South Texas Project Electric Generating Station 4000 Avenue F – Suite A Bay City, Texas 77414

August 26, 2009
U7-C-STP-NRC-090119

South Texas Project
Units 3 and 4
Docket Nos. 52-012 and 52-013
Response to Request for Additional Information

Attached are the responses to the NRC staff questions included in Request for Additional Information (RAI) letter number 163 related to Combined License Application (COLA) Part 2, Tier 2, Section 9.2. This submittal and the reference complete the response to this RAI letter.

FIGURE 9.2-9b POTABLE WATER SYSTEM P&ID

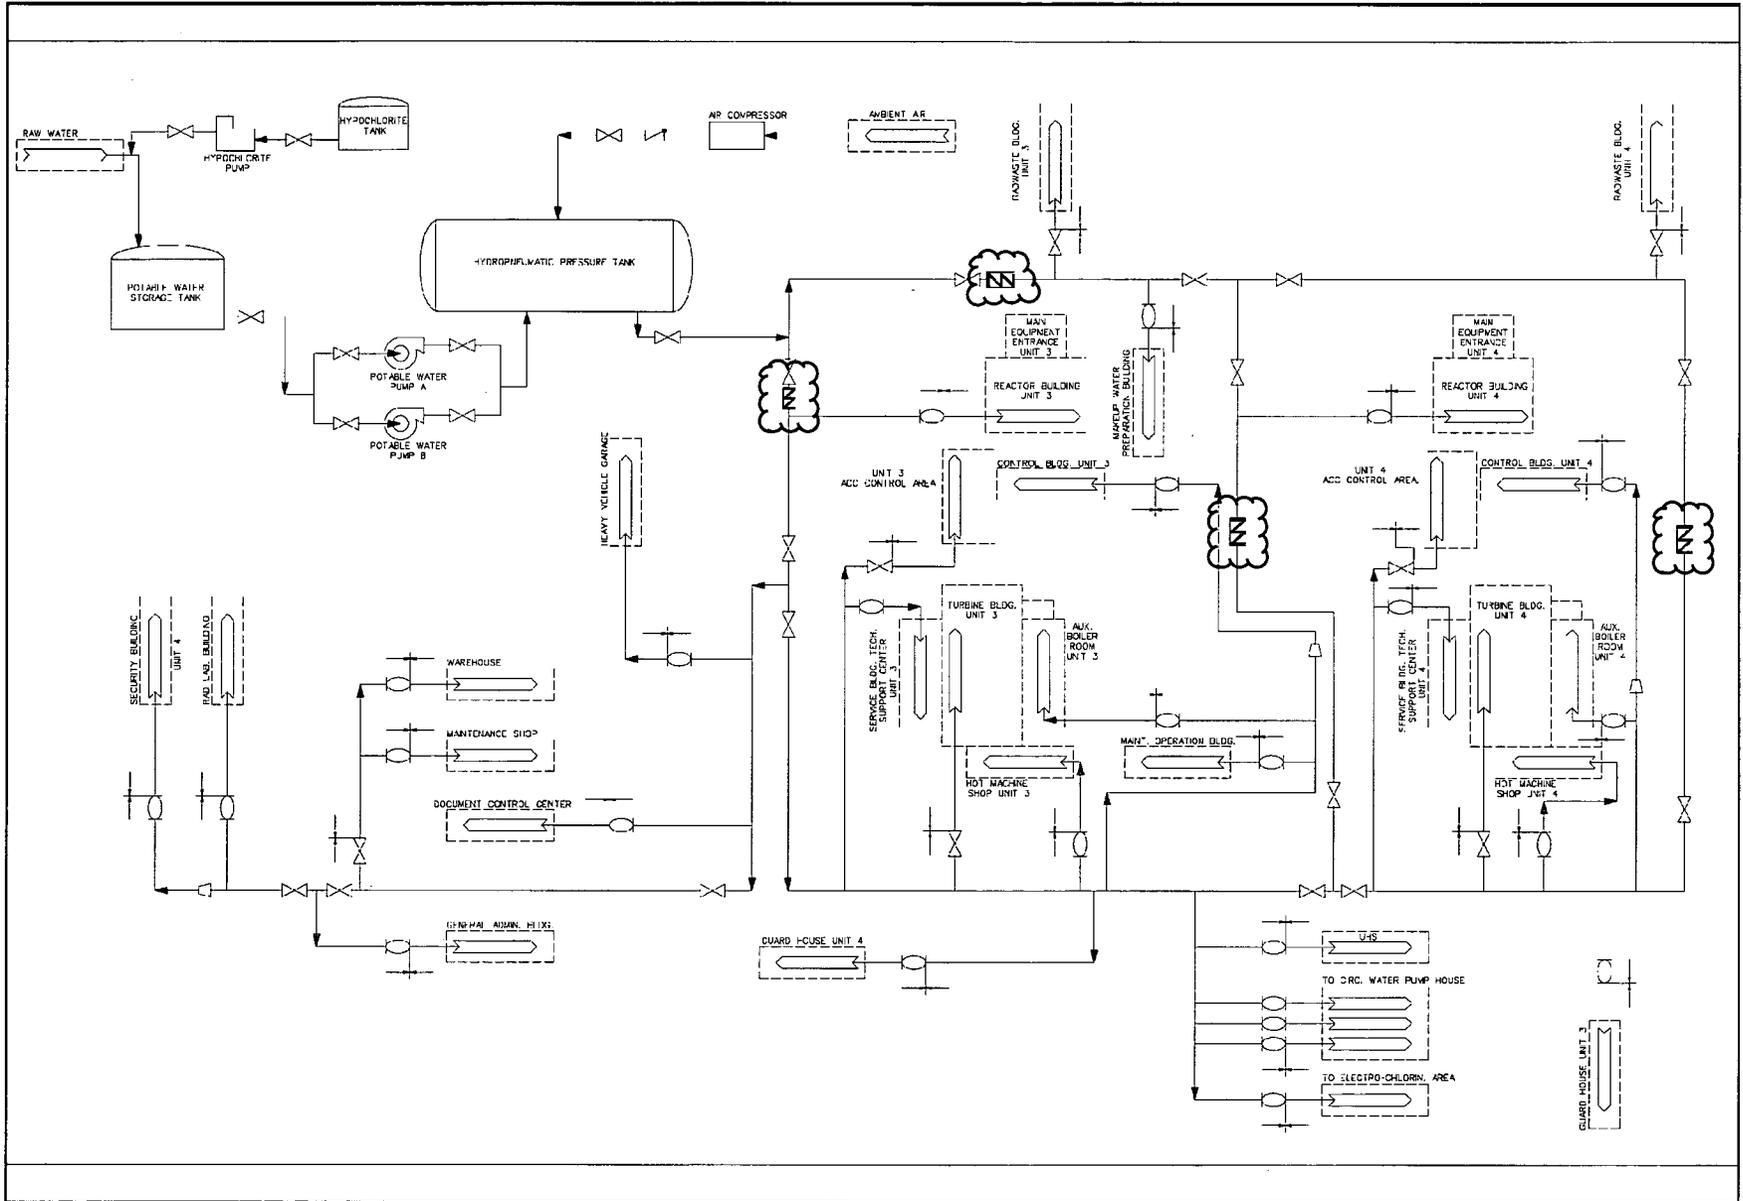
STP DEP 9.2-8, "Potable and Sanitary Water System," addresses several plant modifications, including the change from a single unit to dual units (STP 3&4) that is described in STP DEP 1.1-2. The change from a single unit to a dual unit design means that there may be the possibility for radioactive contamination introduced into the PSW at one unit to spread into another unit by means of shared equipment and/or cross-connections. Per the STP COL, the sewage treatment and sanitary drainage systems will collect and process sanitary waste for all four units at the site. However, the STP COL does not appear to explicitly indicate whether or not there are any cross-connections between potable water supply systems.

Describe how the proposed PSW System design precludes the potential for cross-contamination between units and compliance to Bulletin 80-10 and acceptance criteria II.1.C in SRP 9.2.4. Include this information in the STP COL FSAR and provide a markup in your response.

In section 9.2.4 of the STP COL application, Figure 9.2-9, "Potable and Sanitary Water System (Sheet 1 of 2)," is provided, however, sheet 2 of 2 for Figure 9.2-9 was not included. Furthermore, Figure 9.2-9 is not included in Chapter 21 of the FSAR. Please provide Figure 9.2-9, sheet 2 of 2.

The only cross-connection between the Potable and Sanitary Water Systems for Units 3 & 4 occurs where the discharge of the Hydropneumatic Storage Tank splits for Units 3 & 4. A backflow preventer will be provided for both Unit 3 and Unit 4 to prevent cross contamination in the event that one unit becomes contaminated. Additionally, a backflow preventer will be provided at the entrance to each building supplied by the Potable and Sanitary Water System to prevent cross-contamination.

As a result of this RAI response, COLA Part 2, Tier 2, Subsection 9.2.4.2.5 will be revised as shown below. In addition, the Potable and Sanitary Water P&ID (Figure 9.2-9b) will be revised to show the backflow preventers as shown in the attached markup of Rev 2 of the COLA.

The PSW system will be designed with no interconnections with systems having the potential for containing radioactive materials. Protection will be provided through the use of air gaps, where necessary. A backflow preventer will be provided for both Unit 3 and Unit 4 to prevent cross contamination in the unlikely event that a unit becomes contaminated with radioactive materials. Additionally, a backflow preventer will be provided at the entrance to each building supplied by the Potable Water System to prevent cross-contamination.

As a result of this response, the COLA will be revised as shown in the attached markups to Rev 2 of the COLA in order to provide consistency in the numbering of this figure. Text changes are shown with gray highlighting and the title of Figure 9.2-9 is revised as shown.

FIGURE 9.2-9b POTABLE AND SANITARY WATER SYSTEM P&ID (Sheet 2 of 2)
